Individuals

RE: Draft EIR for the RiverPark Project

Re: RiverPark Specific Park Draft EIR

FIGURE 2-28

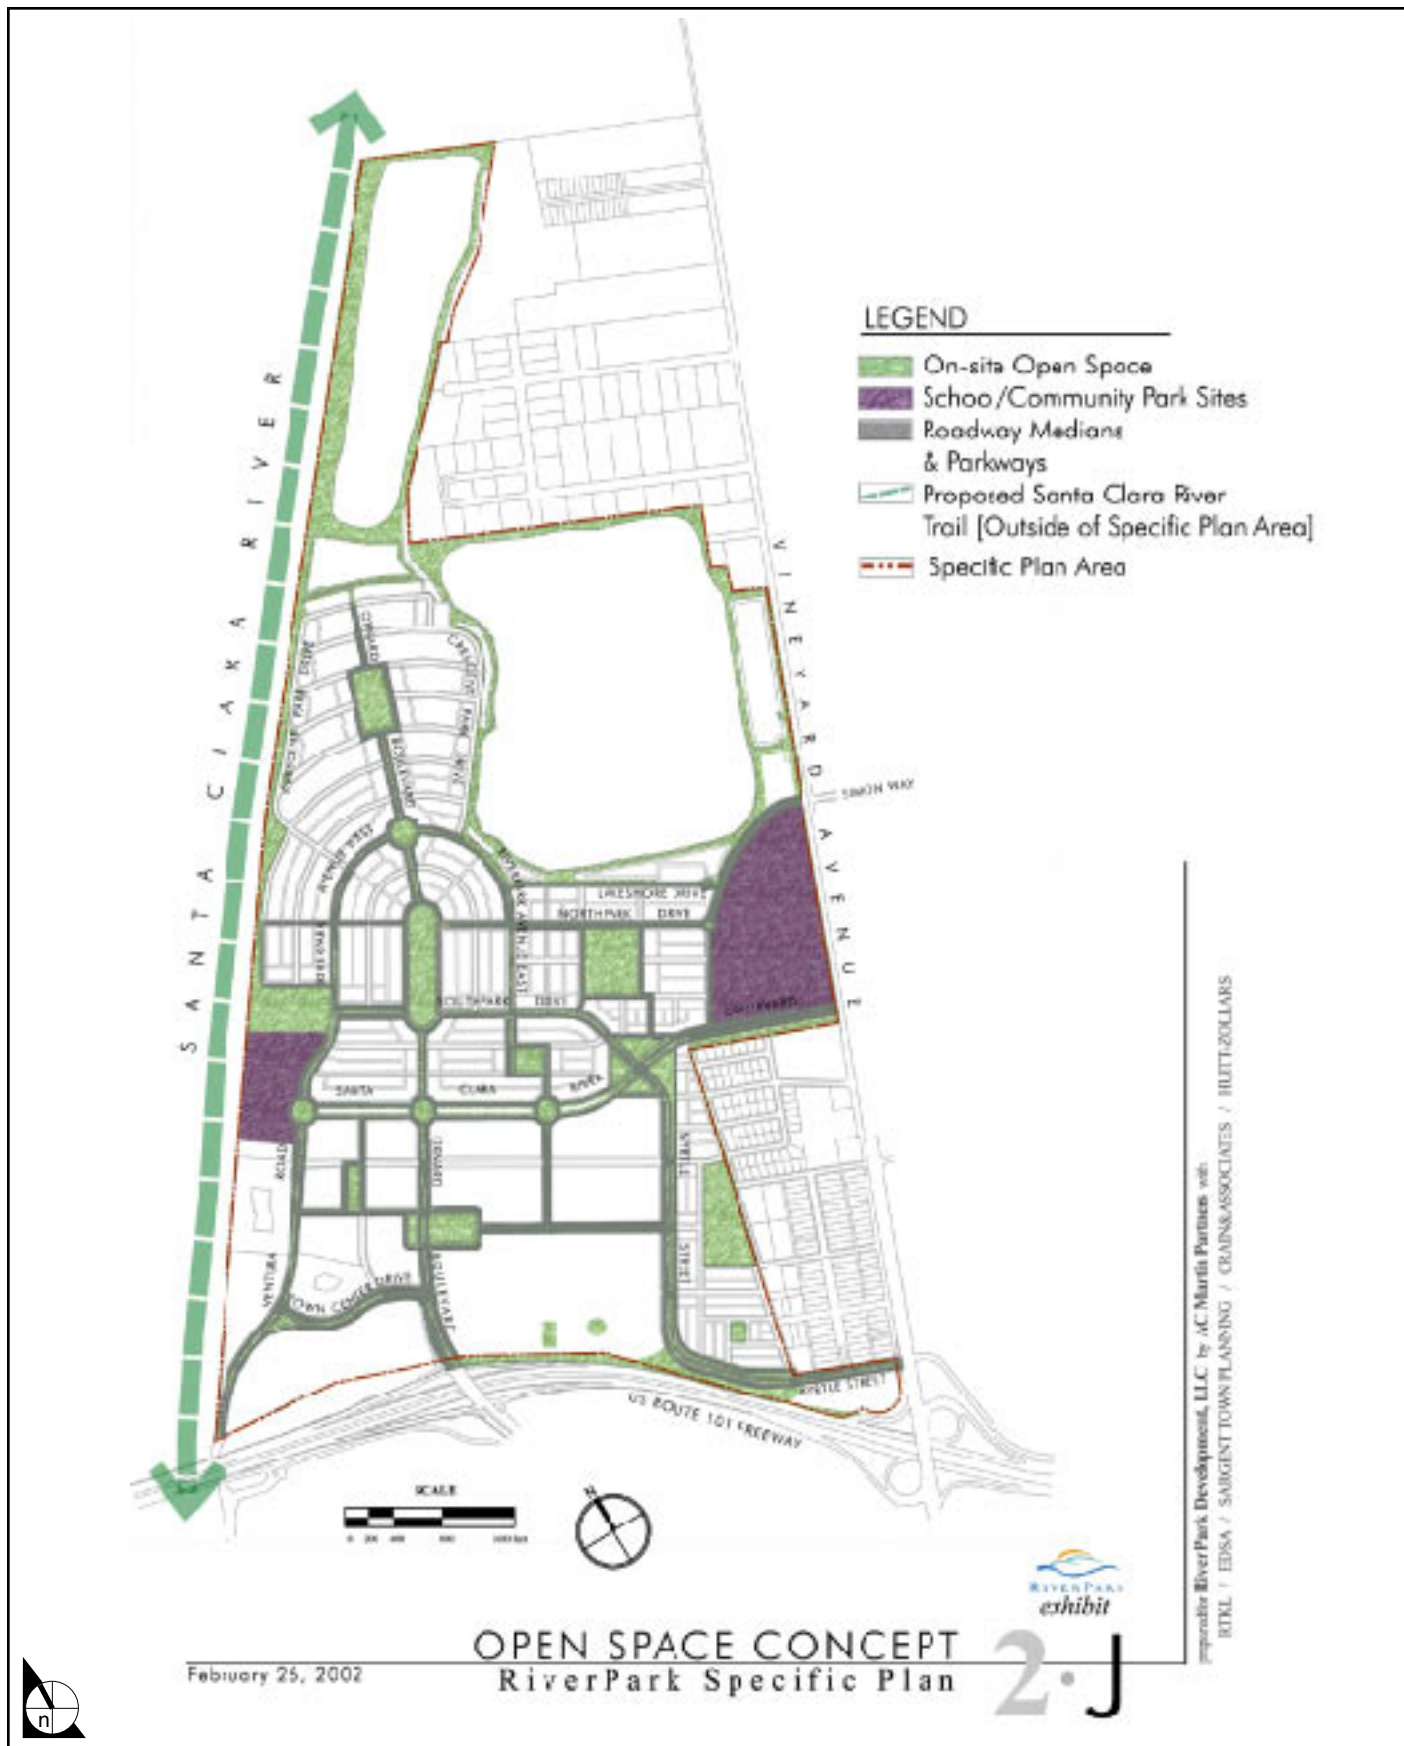
- ♦ The number and size of neighborhood parks is inadequate for the number of people who will potentially use them. The proposed parks are too small to provide enough open space for all the residents in the area. DG-4

- Why are there not more parks? Big houses on small lots and no place for kids to play make for a dangerous and unhappy community. Two neighborhood parks for the estimated 2800 new homes, in addition to all the people form the existing neighborhoods in El Rio is not enough. Parks and Reaction told me that all the other new communities have parks of 6 Acers. We have waited for 25 years for a park in our neighborhood we do PM-5

not want nor do we deserve less the another neighborhoods.

The RiverPark Specific Plan includes a variety of park facilities including three neighborhood parks and smaller open spaces adjacent to the planned residential neighborhoods to meet neighborhood park needs, as shown on the **Figure 2-28** following this page. The City's park planning standard, as defined in the General Plan Parks and Recreation Element and discussed in Section 4.10.4, Parks and Recreation, of the Draft EIR, is 1.5 acres of neighborhood park space and 1.5 acres of community park land for each 1,000 residents. Based on this standard, approximately 11 acres of neighborhood park land and 11 acres of community park land is required to meet the needs of the residents of RiverPark. As originally proposed and assessed in the Draft EIR, the RiverPark Specific Plan included 13 acres of neighborhood park land in three neighborhood parks located in the southern, central and northern portions of the Specific Plan Area in residential neighborhoods. These neighborhood parks were distributed throughout the community to ensure that neighborhood park space is within easy walking distance of all residential areas. Access to these parks will be enhanced by the pedestrian and bicycle network planned throughout the community.

Based on review of the Draft Specific Plan by the staff of the Oxnard Parks and Recreation Department, the size of these three neighborhood parks has been increased. The park in Planning District F, located next to the existing El Rio West Neighborhood, has been increased in size to 7.4 acres, the park in Planning District J has been increased in size to 6.1 acres, and the park in Planning District has been increased in size to 6.4 acres. The amount of neighborhood parkland in these three neighborhood parks is 19.9 acres. When the 3.3-acre neighborhood park in Planning District H is added, the total amount of neighborhood park space in these four parks is 23.3 acres. This amount of neighborhood park space is over twice the 11 acres required under the City's park planning standards for the 7,220 residents projected for the project.

With regard to community park land, the Specific Plan also provides community playfields in conjunction with the two school sites that will be available for public use outside of school hours. A minimum of 12 acres of community playfields will be provided on these two school sites, an amount that exceeds the 11 acres required under the City's park planning standards. In addition to these community playfields, the RiverPark Specific Plan provides other park and spaces that do not meet the definition of neighborhood or community park space in the Oxnard 2020 *General Plan* Parks and Recreation Element. These facilities, including a network of trails around the community, will help meet the parks and recreation needs of residents of the area.

The RiverPark Specific Plan includes a variety of park facilities including three neighborhood parks and smaller open spaces adjacent to the planned residential neighborhoods to meet neighborhood park needs, as shown on **Figure 2-29** following this page. The City's park planning standard, as defined in

the General Plan Parks and Recreation Element and discussed in Section 4.10.4, Parks and Recreation, of the Draft EIR, is 1.5 acres of neighborhood park space and 1.5 acres of community park land for each 1,000 residents. Based on this standard, approximately 11 acres of neighborhood park land and 11 acres of community park land is required to meet the needs of the residents of RiverPark. As originally proposed and assessed in the Draft EIR, the RiverPark Specific Plan included 13 acres of neighborhood park land in three neighborhood parks located in the southern, central and northern portions of the Specific Plan Area in residential neighborhoods. These neighborhood parks were distributed throughout the community to ensure that neighborhood park space is within easy walking distance of all residential areas. Access to these parks will be enhanced by the pedestrian and bicycle network planned throughout the community.

Based on review of the Draft Specific Plan by the staff of the Oxnard Parks and Recreation Department, the size of these three neighborhood parks has been increased. The park in Planning District F, located next to the existing El Rio West Neighborhood, has been increased in size to 7.4 acres, the park in Planning District J has been increased in size to 6.1 acres, and the park in Planning District has been increased in size to 6.4 acres. The amount of neighborhood parkland in these three neighborhood parks is 19.9 acres. When the 3.3-acre neighborhood park in Planning District H is added, the total amount of neighborhood park space in these four parks is 23.3 acres. This amount of neighborhood park space is over twice the 11 acres required under the City's park planning standards for the 7,220 residents projected for the project.

With regard to community park land, the Specific Plan also provides community playfields in conjunction with the two school sites that will be available for public use outside of school hours. A minimum of 12 acres of community playfields will be provided on these two school sites, an amount that exceeds the 11 acres required under the City's park planning standards. In addition to these community playfields, the RiverPark Specific Plan provides other park and spaces that do not meet the definition of neighborhood or community park space in the Oxnard 2020 *General Plan Parks and Recreation Element*. These facilities, including a network of trails around the community, will help meet the parks and recreation needs of residents of the area.
